#### Photolytic Destruction Technology Technical Memorandum

**Environmental Management of Offgas Technology**

Site S, Operable Unit D

# Response to Comments for the PDT Technical Memorandum II dated April 17, 1996

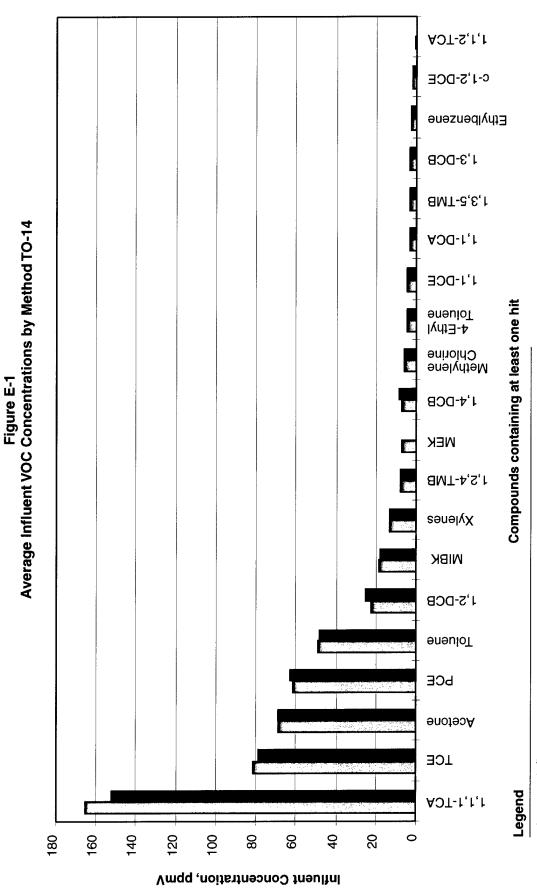
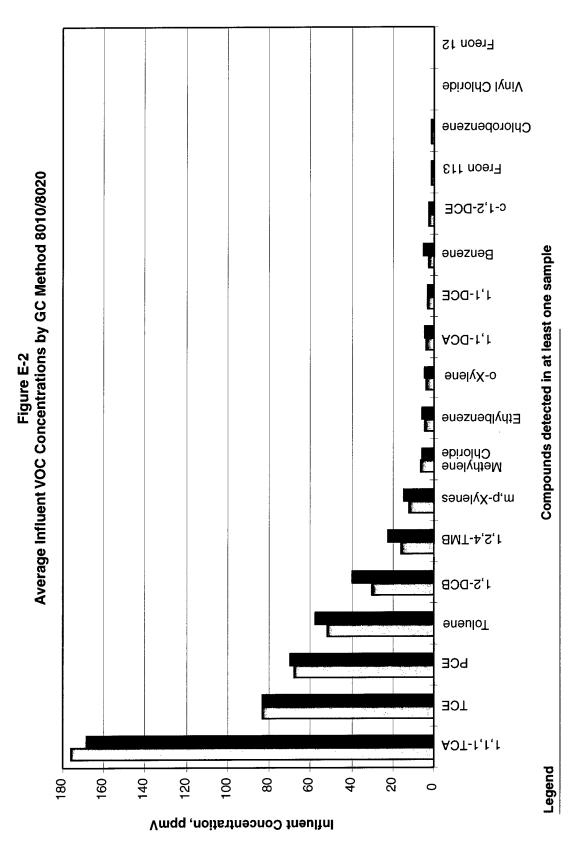
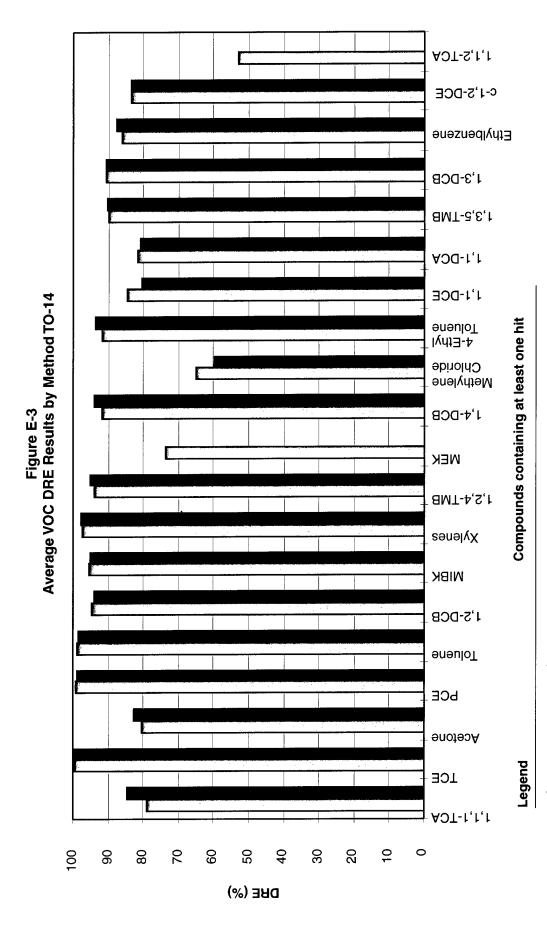
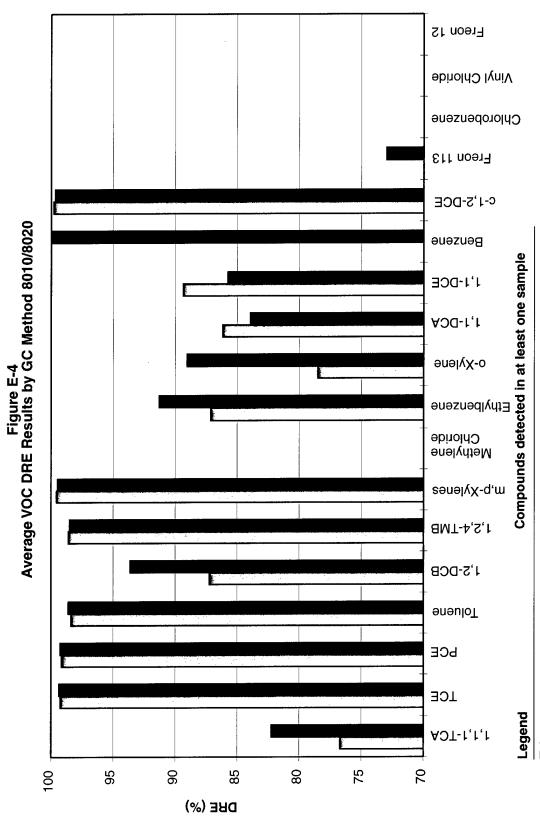
Comment: Figure 6—Move to appendix

Comment: Figure 7—Move to appendix

Comment: Figure 8—Move to appendix

Comment: Figure 9—Move to appendix

Comment: Figure 6-9. The presentation of information in these figures is somewhat confusing. It would be helpful if the compounds that are in all the figures were listed first and in the same order. This would make it easier to compare the results of one method versus the other.

Comment: Also, the distinction between the two types of data listed in the legend needs clarification. The first appears clear, "Average of all samples collected." The second is ambiguous. Is it the average after a certain date? Is it the average of multiple samples taken on the same date? What is the significance of the date?

Response: Agree. Renamed Figure 6 to Figure E-2 and moved to Appendix E.

Response: Agree. Renamed Figure 7 to Figure E-4 and moved to Appendix E.

Response: Agree. Changed Figure 8 to Figure E-1 and moved to Appendix E.

Response: Agree. Changed Figure 9 to Figure E-3 and moved to Appendix E.

Response: Agree. Explanatory text on the figures has been improved. Note, per comments by Tim Chapman/BDM, the figures have been moved to Appendix E and Figures E-1, E-2, E-3, and E-4, and Tables 1 through 4 have replaced them in the main text.

Response: Agree. The second average is the average DRE for all samples collect between December 1, 1995, and the conclusion of the demonstration. Text has been added to the legend(s) to clarify this point. The significance December 1, 1995 is that it is the first sample date following the installation of the new cooling plenums. Please see the discussion under VOC Destruction Removal Efficiency for further explanation.
